11 LEE MAN STREET

Job No: BP#2014-01802
 11 Leeman
 Street

ONE AND TWO FAMILY	PLAN REVIEW	CHECKLIST
Soil type/Presumptive Load Value (Table R401.4.1) _____		
Component	Submitted Plan	Findings/Revisions/Dates
STRUCTURAL		
Footing Dimensions/Depth (Table R403.1 & R403.1(1), (Section R403.1 & R403.1.4.1)	Requested clarification of sonotube layout.	OK per plan revisions
Foundation Drainage, Fabric, Damp proofing (Section R405 & R406)	NA	
Ventilation/Access (Section R408.1 & R408.3) Crawls Space ONLY	NA	
Anchor Bolts/Straps, spacing (Section R403.1.6)	Provide size of anchor bolts.	OK per plan revisions
Lally Column Type (Section R407)	NA	
Girder & Header Spans (Table R502.5(2))	NA	
Built-Up Wood Center Girder Dimension/Type	NA	
Sill/Band Joist Type & Dimensions	NA	
First Floor Joist Species Dimensions and Spacing (Table R502.3.1(1) & Table R502.3.1(2))	NA	
Second Floor Joist Species Dimensions and Spacing (Table R502.3.1(1) & Table R502.3.1(2))	NA	
Attic or additional Floor Joist Species Dimensions and Spacing (Table R802.4(1) and R802.4(2))	NA

A5 BUILDING
SECTIONS

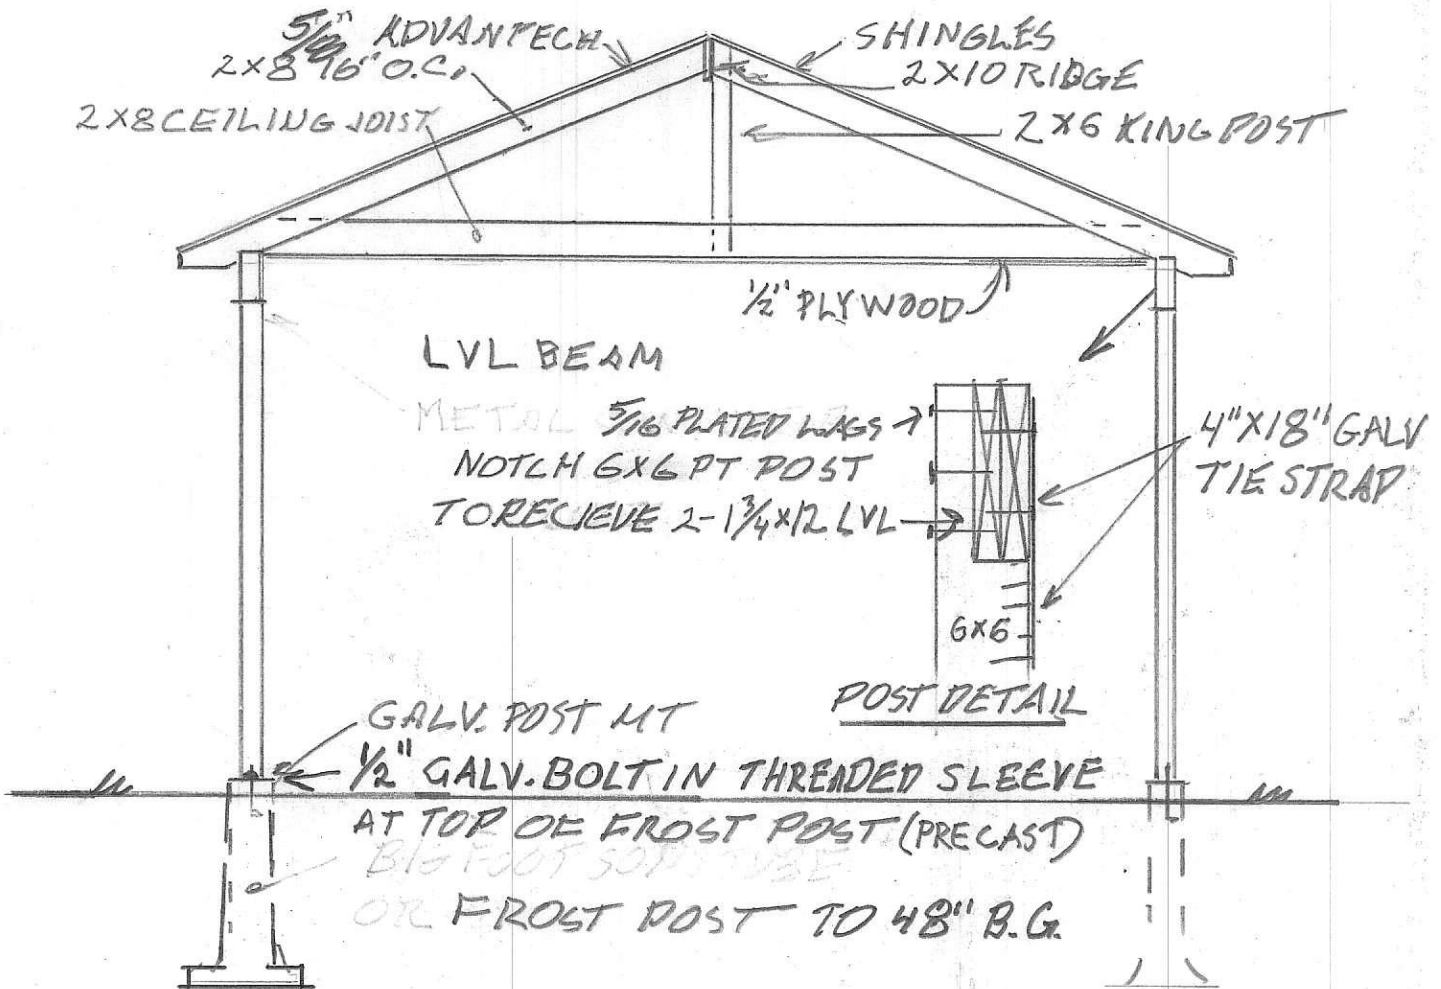
Pitch, Span, Spacing & Dimension (Table R802.5.1(1) - R 802.5.1(8)) Roof Rafter; Framing & Connections (Section R802.3 & R802.3.1)	Size and spacing OK per plans.	
Sheathing; Floor, Wall and Roof (Table R503.2.1.1(1))	Requested roof sheathing be changed to 5/8".	OK per plan revisions.
Fastener Schedule (Table R602.3(1) & (2))		
Private Garage (Section R302.5) Living Space (Above or beside)?	NA	
Table R302.6 Fire separation (Section R302.6)	NA	
Opening Protection (Section R302.5.1)	NA	
Emergency Escape and Rescue Openings (Section R310)	NA	
Roof Covering (Section R905)	Ashpalt shingles OK per plans.	
Safety Glazing (Section R308)	NA	
Attic Access (Section R807)	NA	
Chimney Clearances/Fire Blocking (Chap. 10)	NA	
Header Schedule (Tables R502.5(1) & (2))	NA	
Energy Efficiency IECC, 2009 R-Factors of Walls, Floors, Ceilings, Building Envelope, U-Factor Fenestration Ventilation of Space per ASRAE 62.2, 2007	NA
